SERVICE BULLETIN M20-301

Date: September 19, 2007

SUBJECT: Aircraft "Retrofitted" (Non-Production) with Garmin GFC700 - Manual Electric Trim Installation.

Figure SB M20-301-1 - Control Wheel Harness - Wire Identification

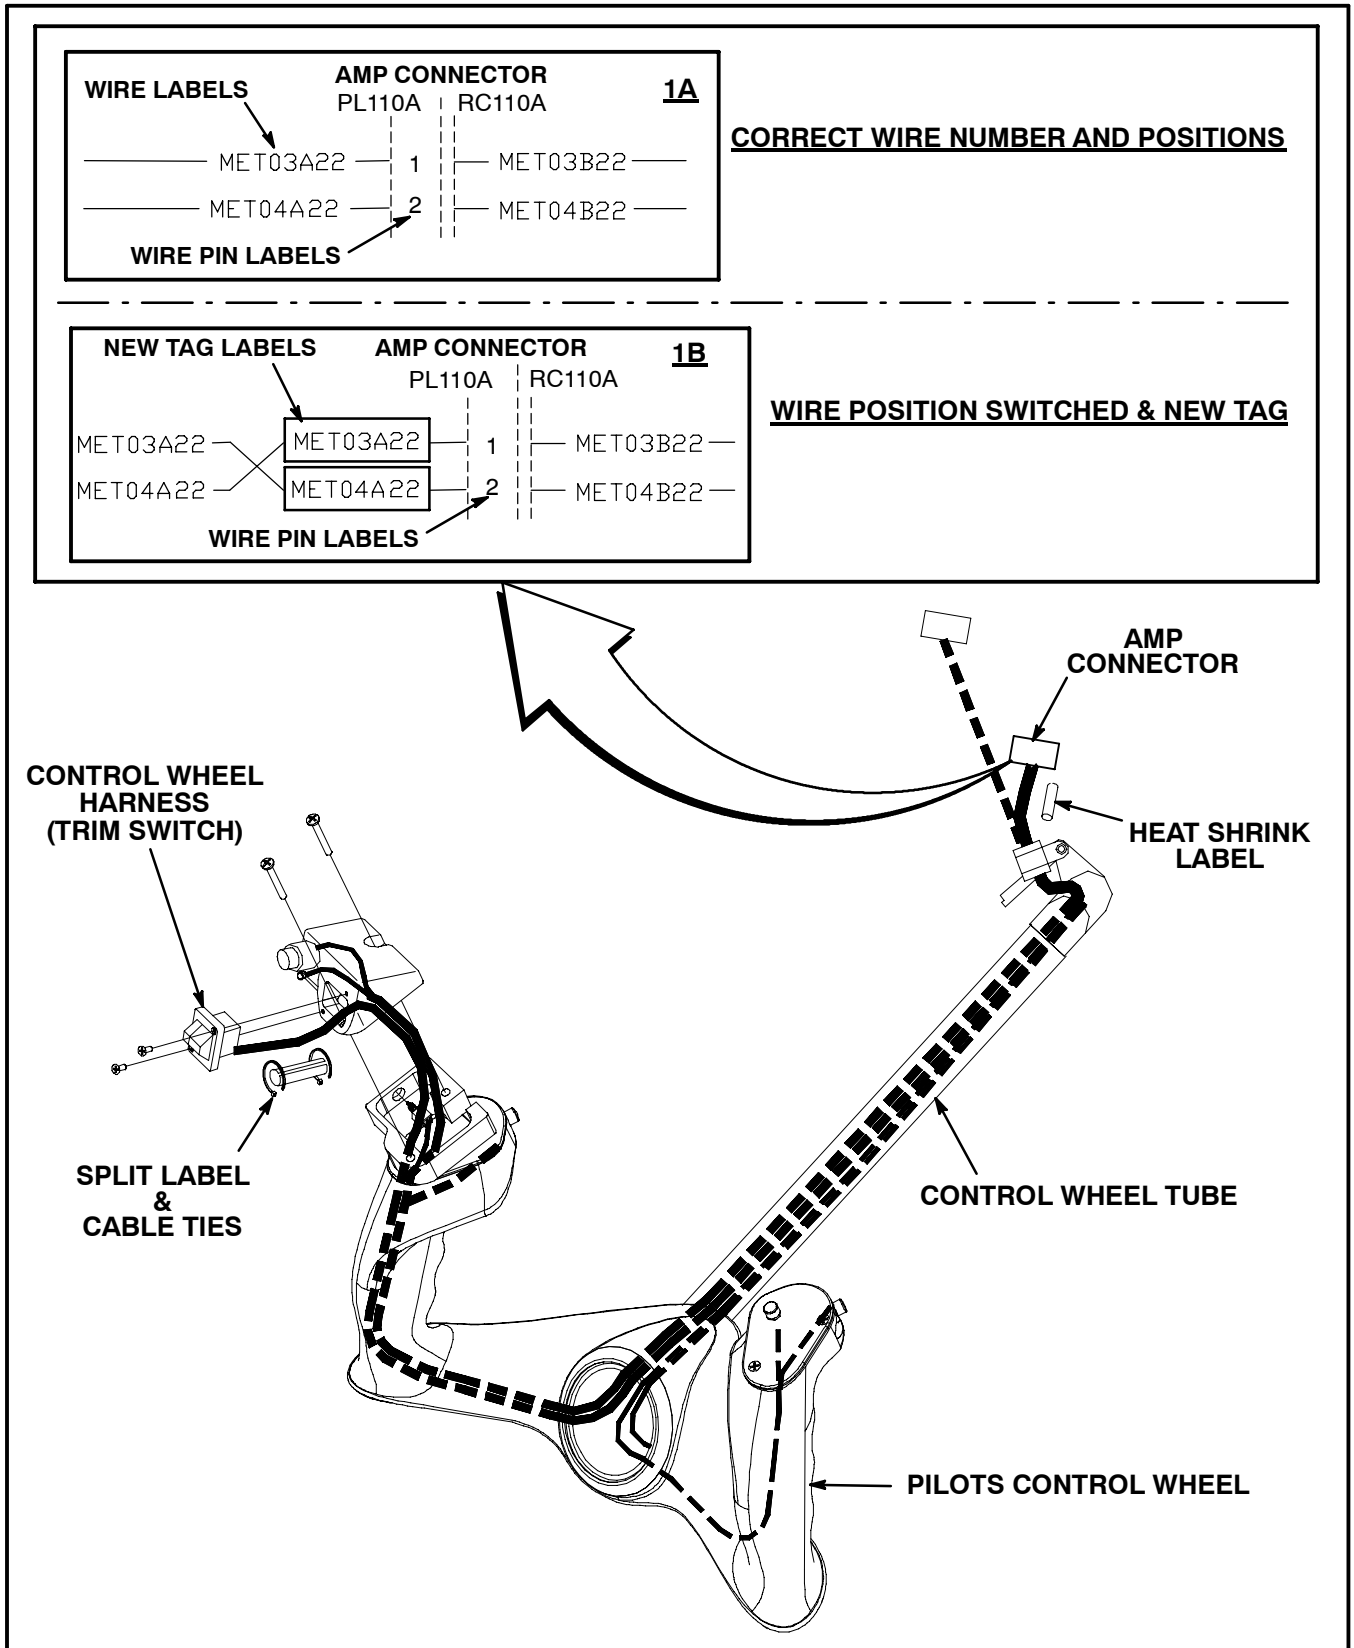
INTRODUCTION: There has been a reported incident, of Garmin GFC-700 Manual Electric Trim switch wires being labeled incorrectly. Results indicated the switch had two wires incorrectly labeled in an Aircraft "Retrofitted" with GFC700 Manual Electric Trim Retrofit kit (NOT a production installation). **FAA requires the attached compliance card be filled out and returned to Mooney Airplane Company.**

- 2-1. Turn master switch - OFF.
- 2-2. Remove LH and RH Tailcone access panels, disconnect batteries.
- 2-3. Locate AMP connector with specified wires at end of the Pilot's Control Wheel tube (ref Figure M20-301-1).
- 2-4. Note each wire number and location, remove #1 and #2 pin wires from the [PL110A] connector using an AMP extractor tool (ref Figures M20-301-1 & 2).
- 2-5. Complete a functional test by temporarily reversing original position of the #1 and #2 pin wires in the [PL110A] connector (ref Figures M20-301-1 & 2).
- 2-6. Connect batteries.
- 2-7. Turn master switch - ON.
- 2-8. Operate Manual Electric Trim through range of motion ensuring correct upward and downward position of Trim Indicator. If trim is functioning properly proceed to **Step 3**.

- 3-1. Turn master switch - OFF.
- 3-2. Identify specified wire labels at end of the Pilot's Control Wheel tube (ref Figures M20-301-1 & 2).
 - a.) If Manual Electric Trim wire labels comply with print, proceed to **Step 3-21**.
 - b.) If Manual Electric Trim wire labels are switched, continue with this procedure.

- 3-8. Place Heat Shrink label (P/N HT-MET03A22) over #1 pin wire (at PL110A) with corrected wire number. Cover any portion of original wire identification marks with heat shrink label, heat label to wire surface as required (ref Figure M20-301-1).

- 3-9. Place split label (P/N SPL-MET03A22) over #1 pin wire (at PL110A) with corrected wire number. Cover any portion of original wire identification marks, cable tie to wire surface as required (ref Figure M20-301-1).

- 3-13. Place Heat Shrink label (P/N HT-MET04A22) over #2 pin wire with correct wire number. Cover any portion of original wire identification marks with heat shrink label, heat label to wire surface (ref Figure M20-301-1).

- 3-14. Place split label (P/N SPL-MET04A22) over #2 pin wire (at PL110A) with corrected wire number. Cover any portion of original wire identification marks, cable tie to wire surface as required (ref Figure M20-301-1).

Figure SB M20-301-1 - Control Wheel Harness Connector

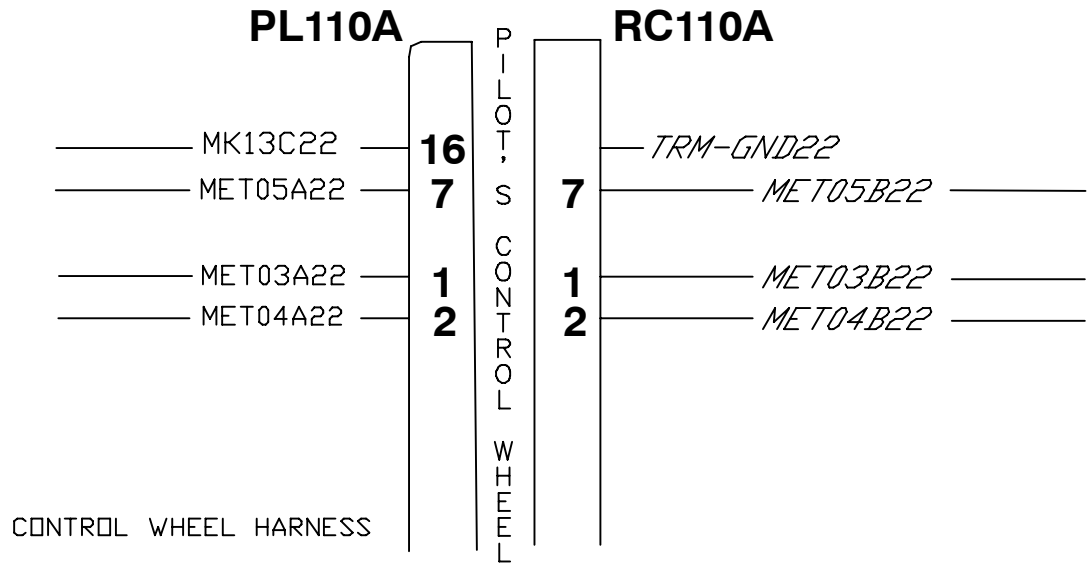
- 3-10. Insert wire labeled MET03A22 into #1 pin position on [PL110A] connector (ref Figures M20-301-1 & 2).
- 3-11. Remove the #2 pin wire from [PL110A] connector.

- 3-15. Insert wire labeled MET04A22 into #2 pin position on [PL110A] connector (ref Figures M20-301-1 & 2).
- 3-16. Reconnect AMP connector at end of the Pilot's Control Wheel tube.
